SUBJECT:
RESPONSE TO NRC LTR DTD 02/23/78...FORWARDING ADDL INFO OF REPT NEDM-20988, "CAORSO RELIEF VALVE LOAD TESTS - TEXT PLANT" WHICH WAS SUBMITTED BY GE ON BEHALF OF THE MARK II OWNERS GROUP.

SUBJECT: MARK II CONTAINMENT REQUEST FOR ADDITIONAL INFORMATION

RESPONSE TO NRC COMMENTS OF JULY 7, 1977 AND FEBRUARY 23, 1978
ON CAORSO TEST PLAN

FIG. 5-2A PIPE AND QUENCHER TEMPERATURE SENSORS

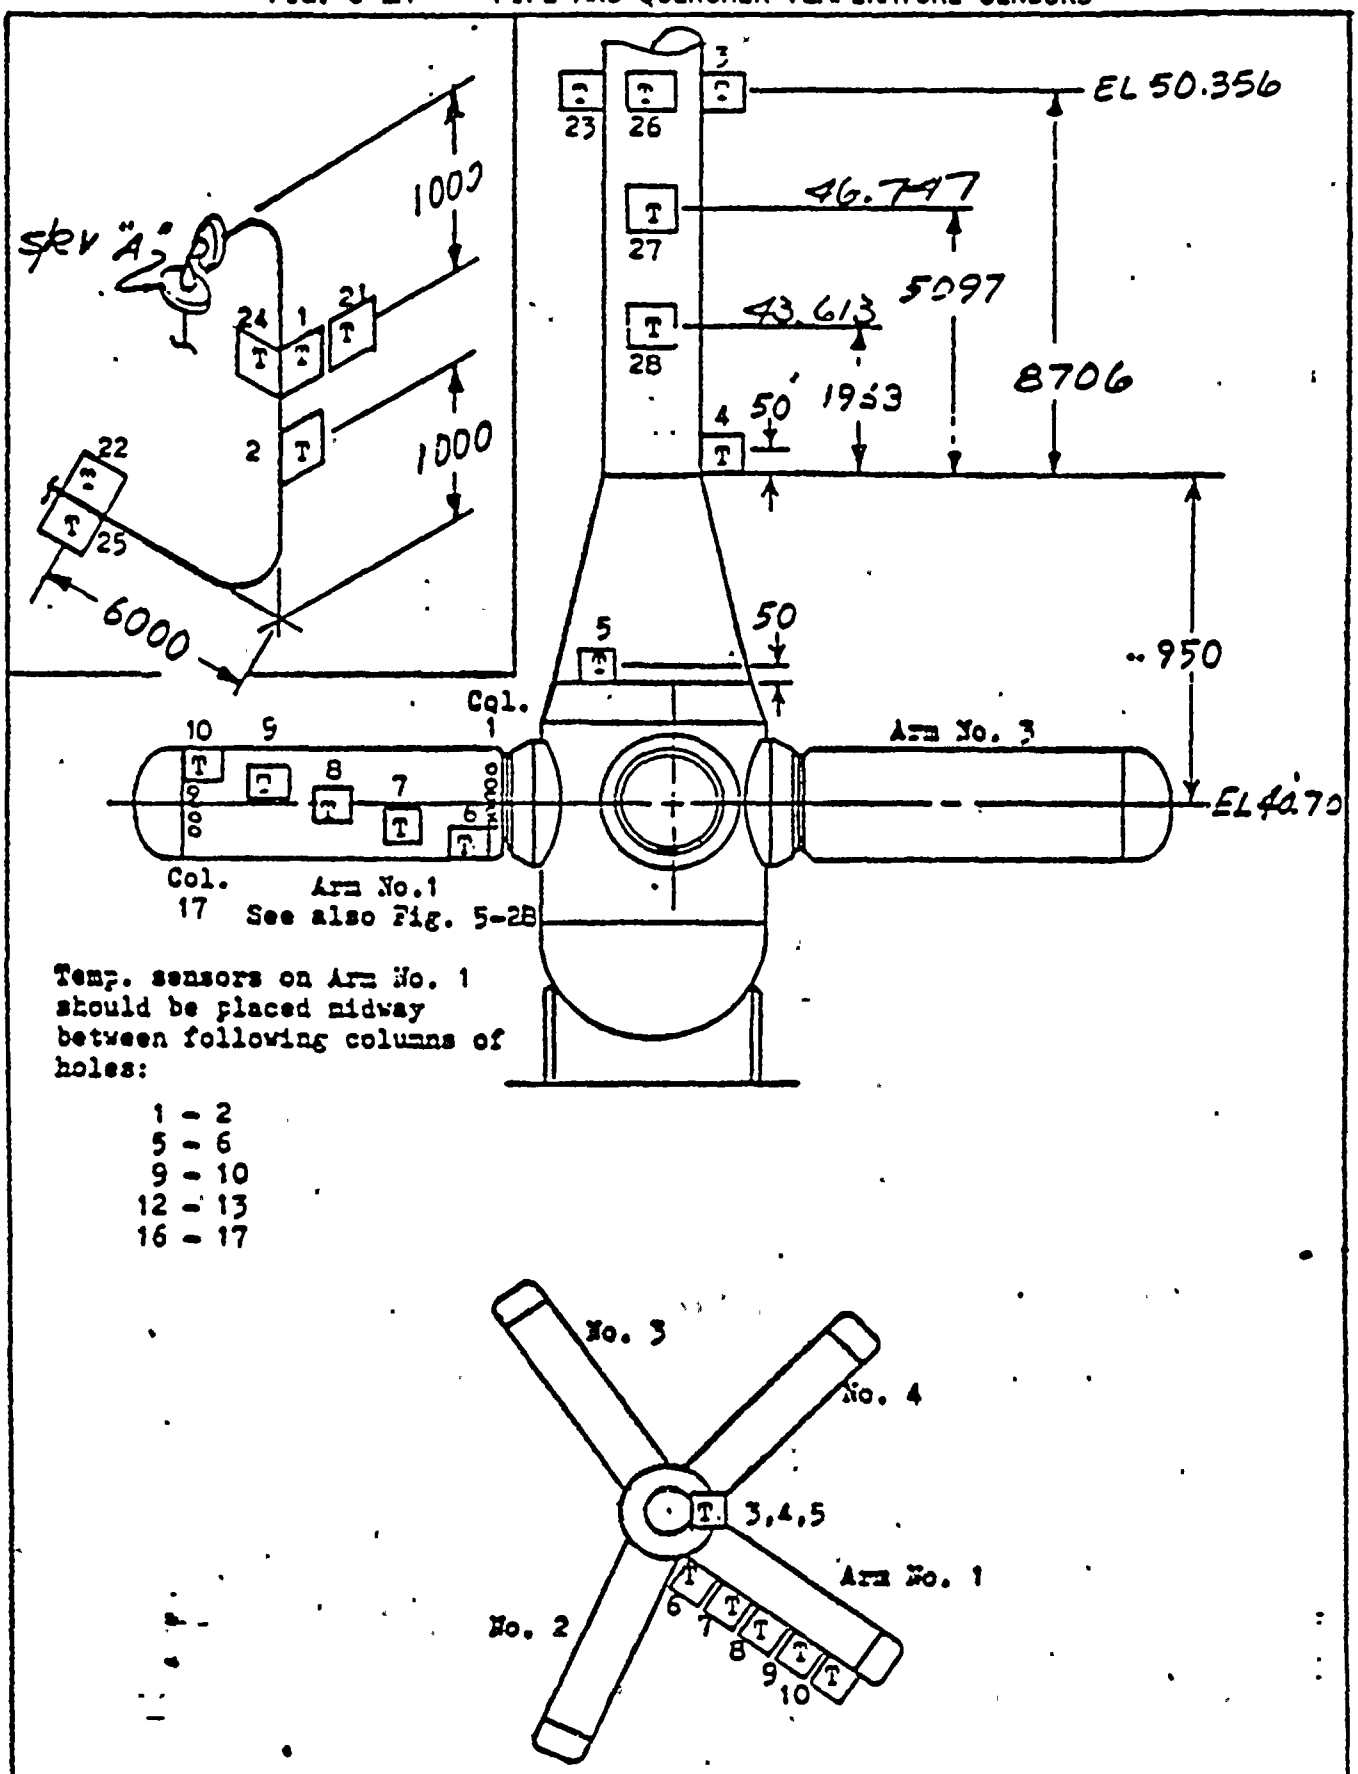
Page 4-6 states that a complete understanding of the subsequent actuation effect requires data on pool temperature in the vicinity of the quencher, pipe temperature and pressure following valve closure, flow rate of air through the vacuum breaker and dynamics of back flow of water. We agree that the air temperature history inside the pipe could be important. However, insufficient information has been given in the test plan regarding the measurement of air temperature in the pipe. Clarify what measurements or calculations will be made to monitor this temperature.

The temperature history of the saturated air-steam mixture inside the SRV discharge line will be measured using sensors T1, T2, T3, and T27 (See attachment (2)). These sensors are designed to measure the temperature of the environment in the discharge line, not the temperature of the discharge line wall. The temperature of the saturated air-steam mixture can be verified using the methods described below.

For the first actuation, the saturated air-steam mixture temperature can be approximated as being equal to the temperature of the discharge pipe inner wall. This temperature will be measured on sensors T24, T25, and T26 (see attachment (2)). For sequential actuations, the air mass will be measured as it enters the discharge line through the vacuum breaker. Given this measured air mass, the discharge line pressure and the total discharge line air-steam mixture volume at the end of the water reflood transient, the temperature of the gas mixture can be calculated using the ideal gas laws by assuming that the steam in the mixture is at saturation corresponding to the discharge line pressure.

FIG. 5-5A POOL PRESSURE SENSORS

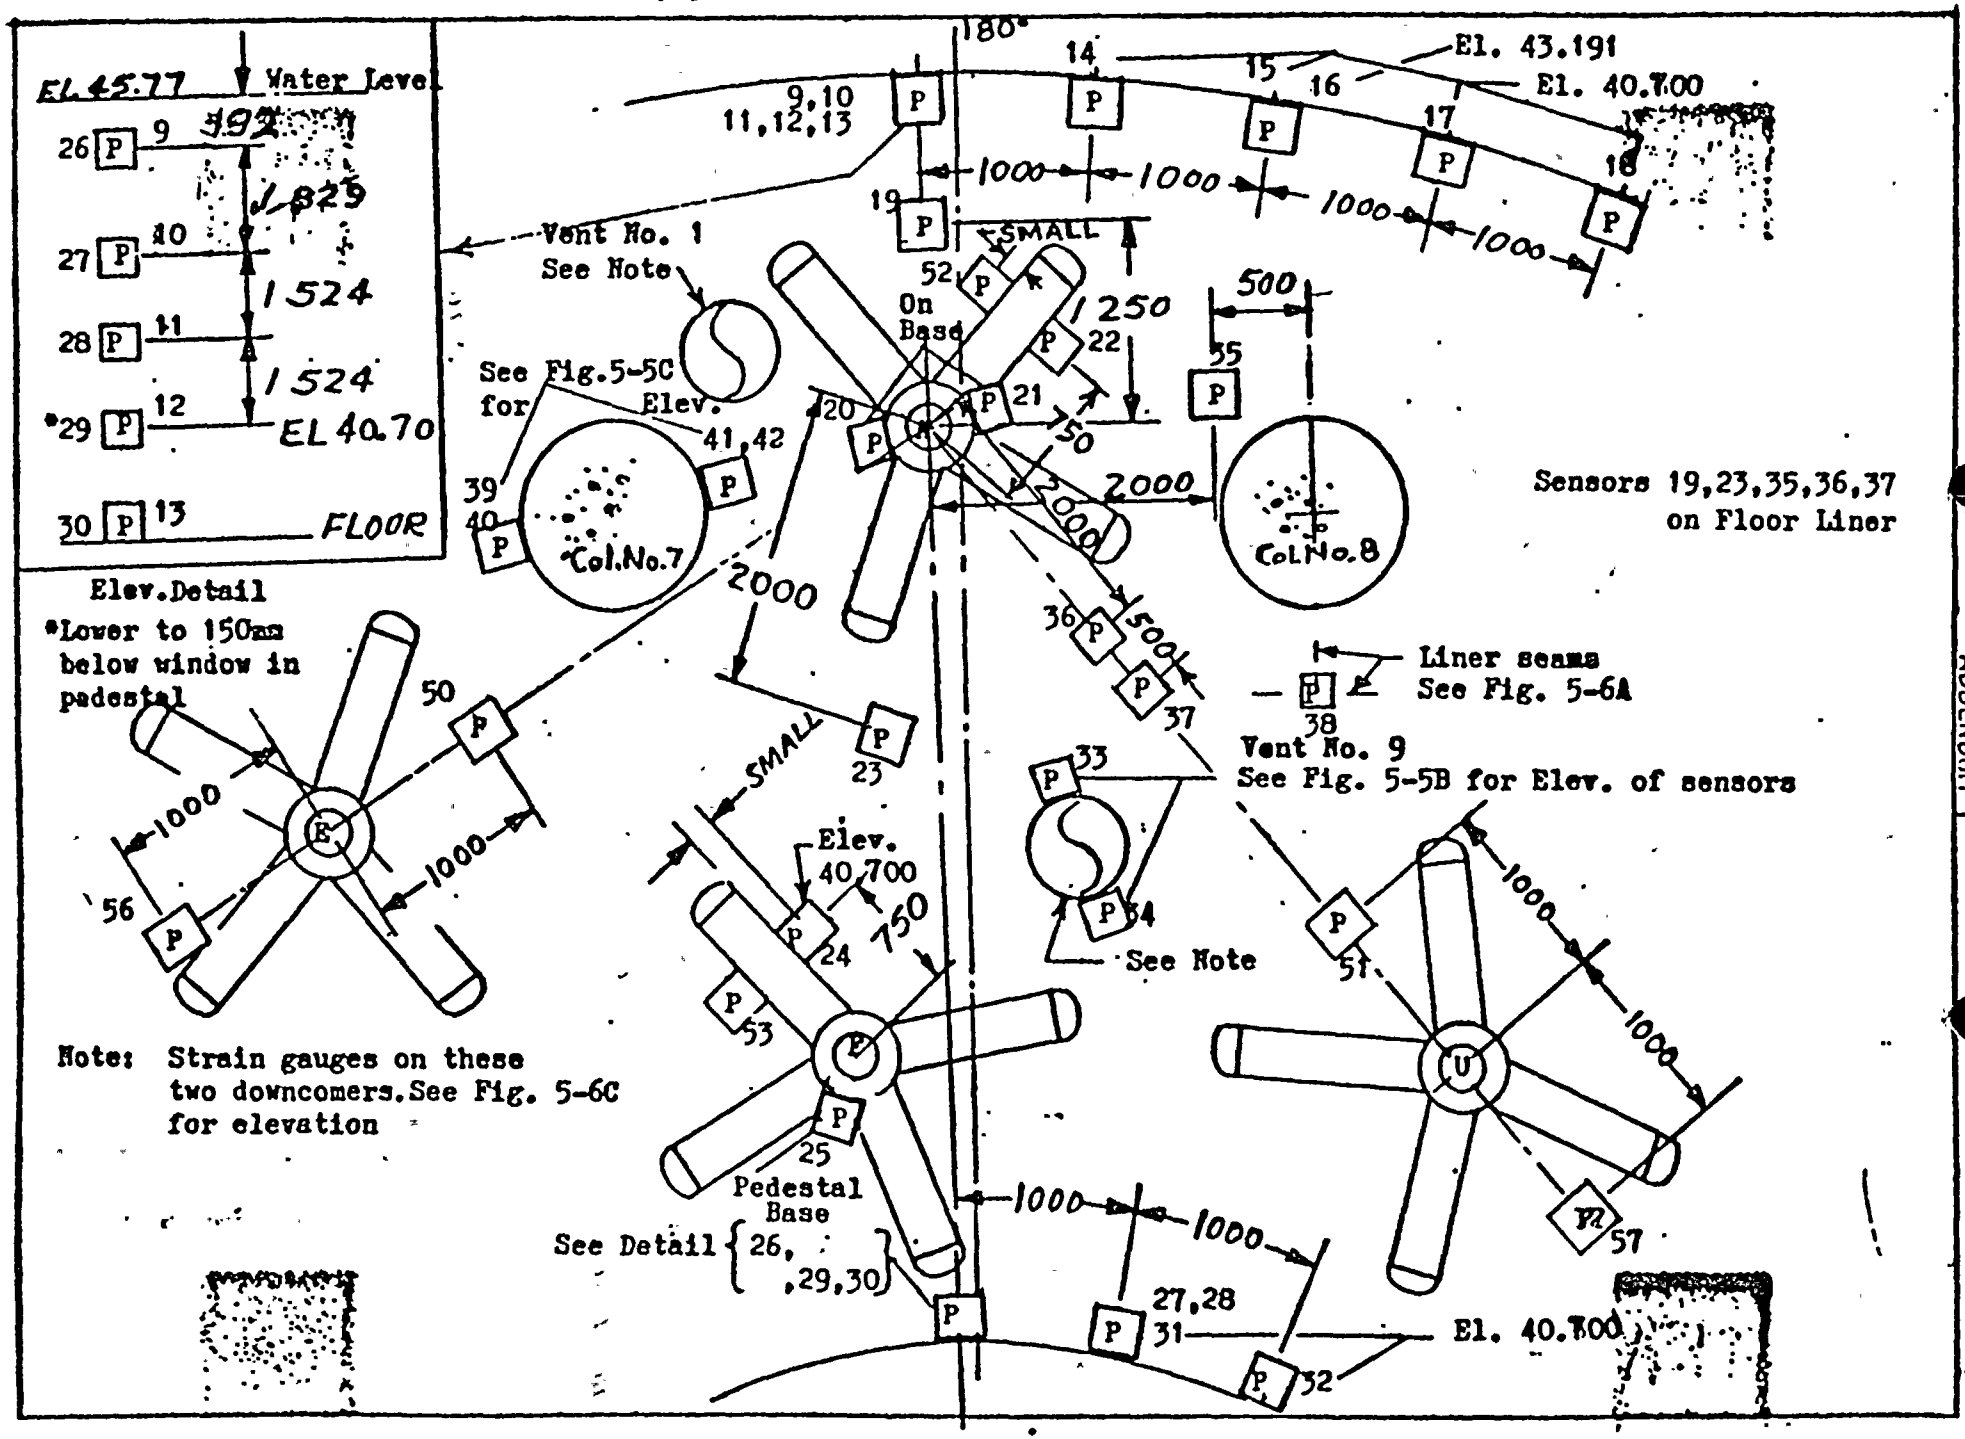
a. The vicinity of Quencher A and the place by which combined loads from multiple SRV's actuation will be determined.

Provide the locations for pressure sensors Nos. 19, 23, 35, 36, and 37.

(a) Slight rearrangement of instrumentation in the suppression pool was accomplished since the issue of revision 2 to the Caorso test plan (NEDM-20988) dated December 1976. Specifically, pressure transducers P36 and P37 were shifted from their original locations near support column 8 to the positions shown on attachment (3). While this shift does not represent a direct backup for sensors P23 and P38, data from these sensors will be sufficient to allow evaluation of multiple valve pop loads should either P23 or P38 fail. At the same time, should sensors P23 and P38 remain intact, sensors P36 and P38 will provide additional useful data which would not be exact duplicates of readings from P23 and P38.
(b) The spacing of level probes L1 and L12 is considered to be of minor importance for the following reasons:

The locations of these sensors are shown in attachment (3).

FIG. 5-3A LEVEL SENSORS

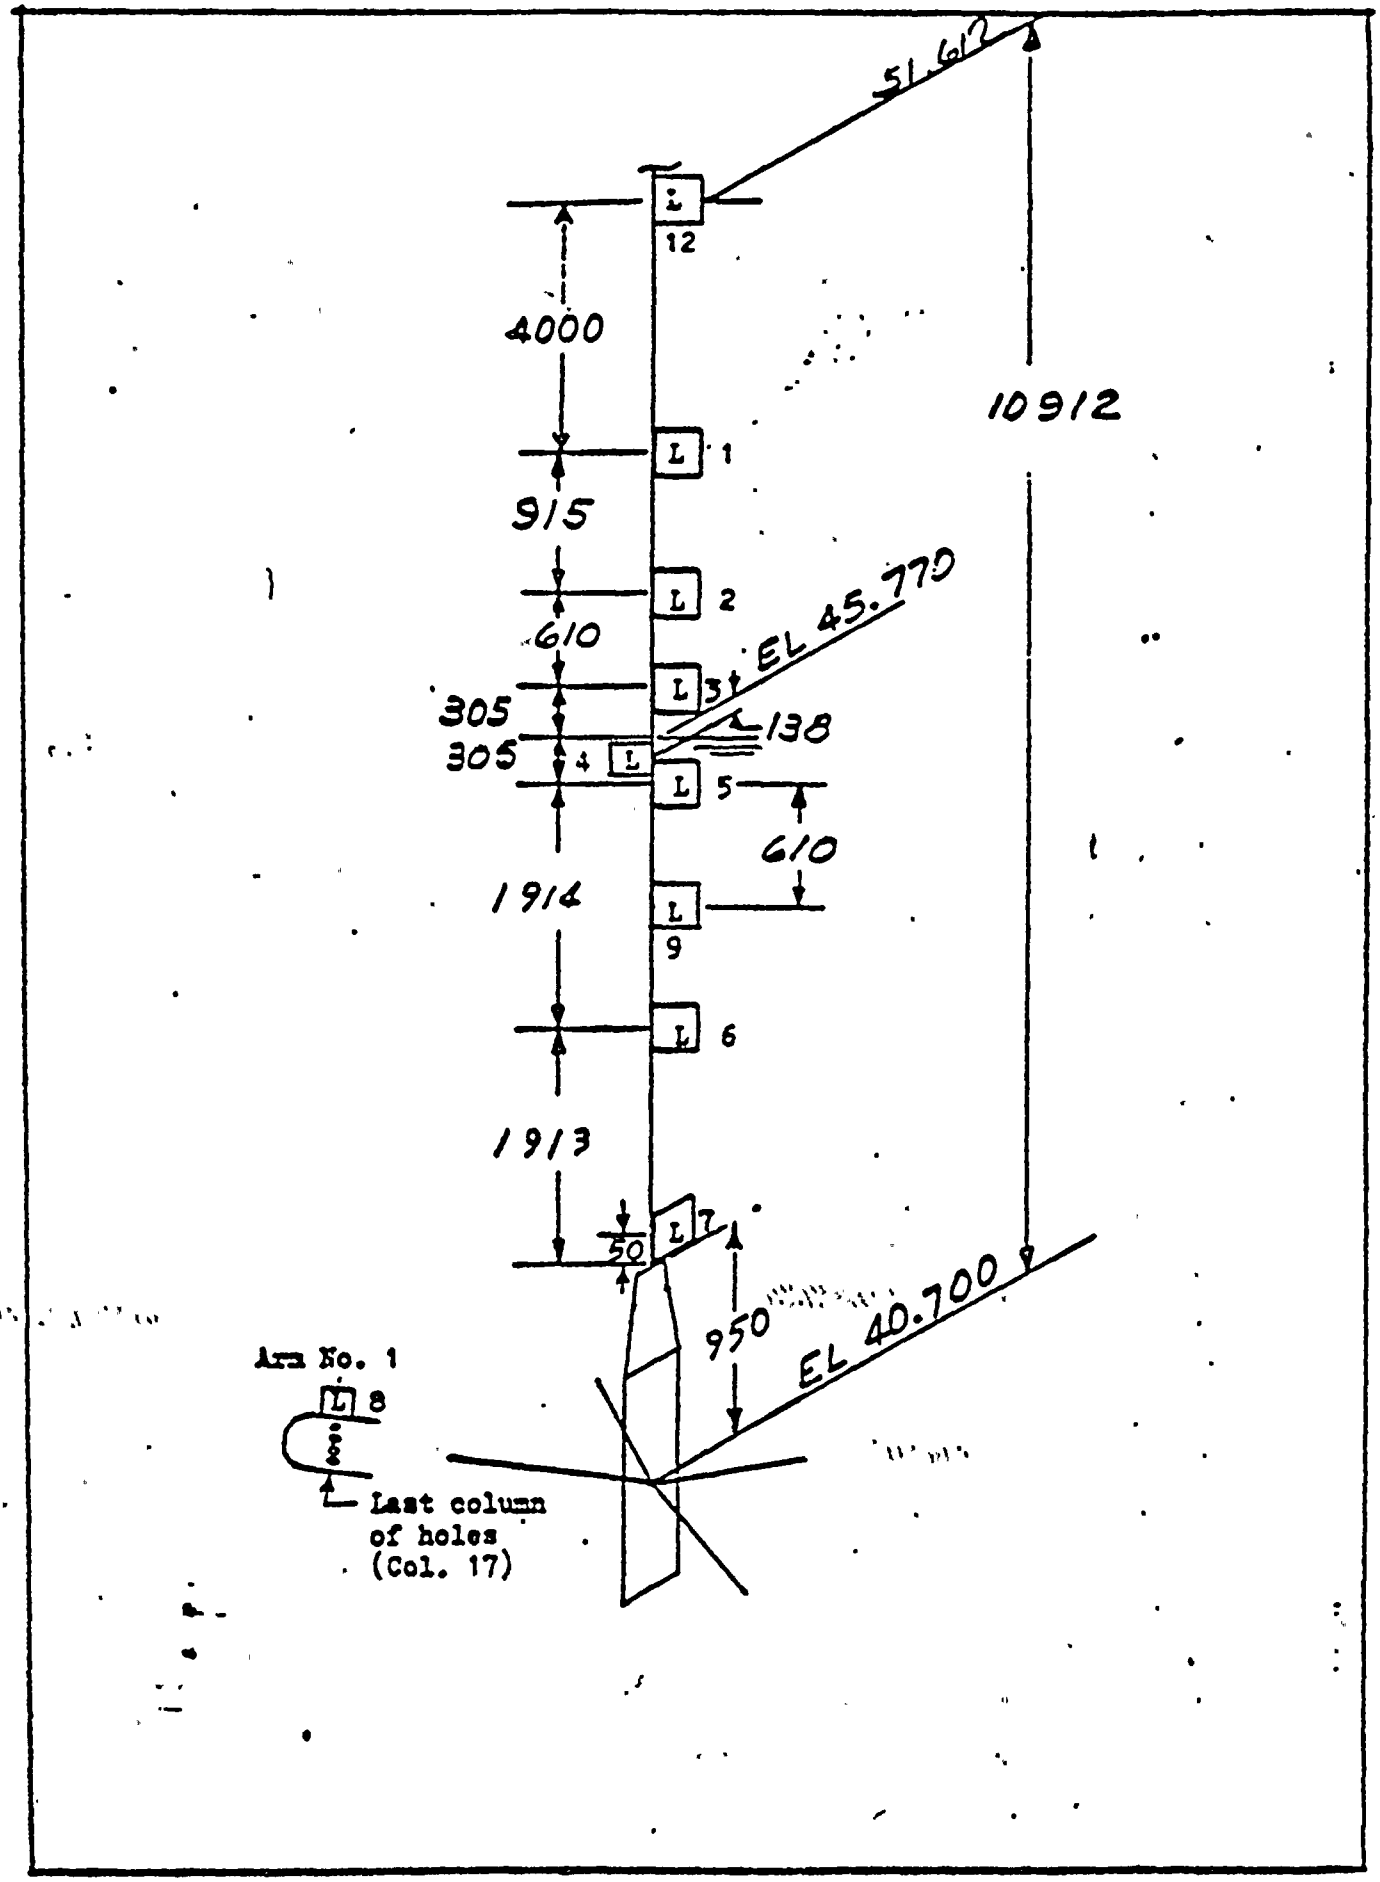
b. SRV line between elevation 51.612 and 45.770. In addition, level probes should be added between L1 and L21.

(2) The large number of level probes between sensors L1 and L7 allow an evaluation of the velocity and acceleration of the water column; this information, in turn, can be used to determine approximately the maximum level to which the water column rises during the reflood transient.

With regard to the question of redunduncy for level probes between elevations 51.612 and 45.770, temperature sensors T3, T4, T5, T27, and T28 can function as level sensors if required and will provide redunduncy for the level probes in case of failure.

FIG. 5-53 DOWNCOMER VENT PRESSURE SENSORS

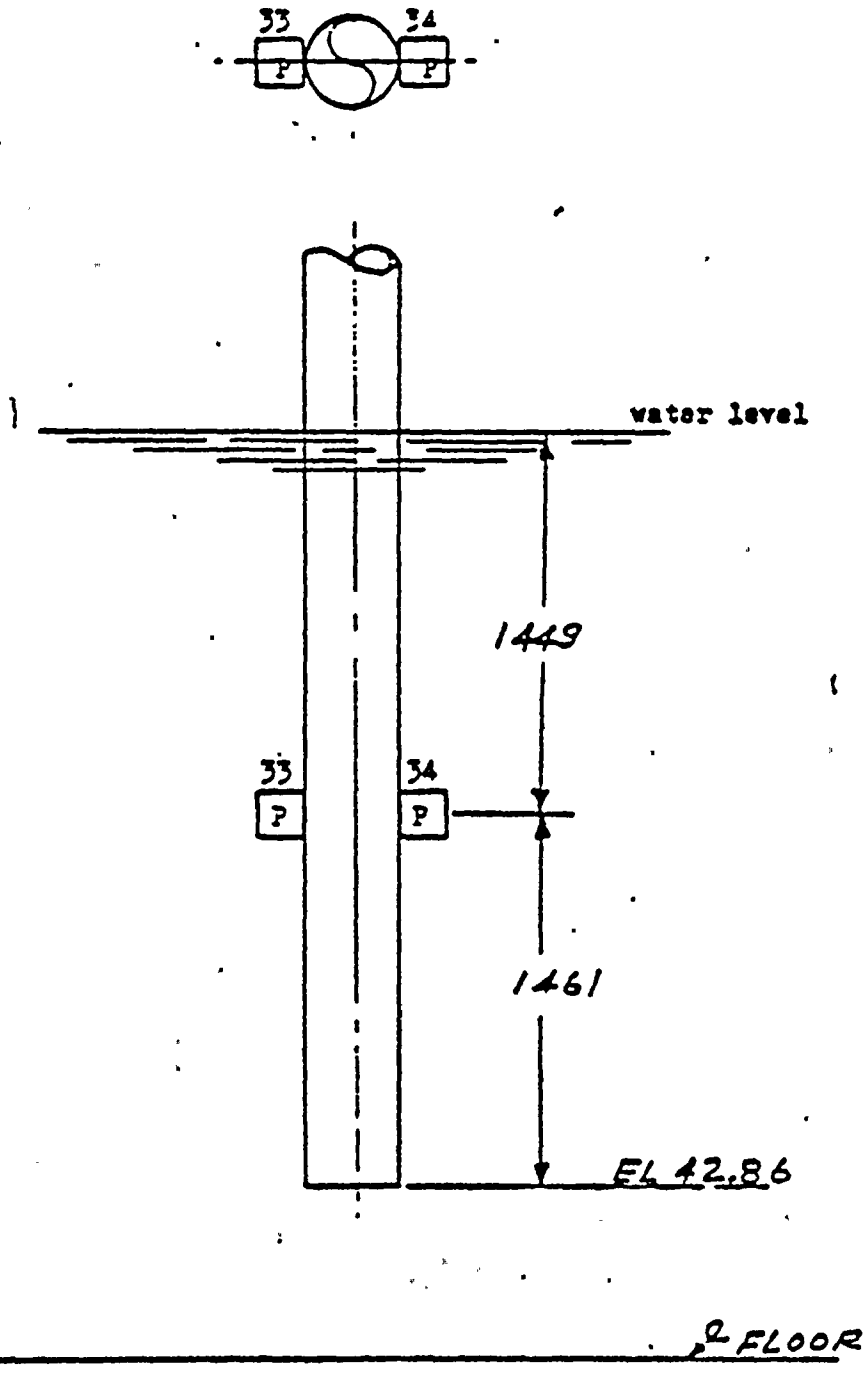
Submerged structure loads have been identified as a primary design load for the Mark II containment. We believe that the analytical program indicated in the Mark II Owners Group meeting which was held on February 16 and 17, 1977, is insufficient to support the design loads for submerged structure without experimental data. Therefore, we recommend that additional pressure sensors should be installed on support columns and downcomers to measure the drag load during SRV operation.

Measurements on two downcomers and a support column adjacent to Quencher A will provide the needed loads information. The instrumentation used, which is shown in attachments 6, 7 and 8 consists of the following:

2. Pressure transducers on Support Column No. 7 and Vent No. 9.
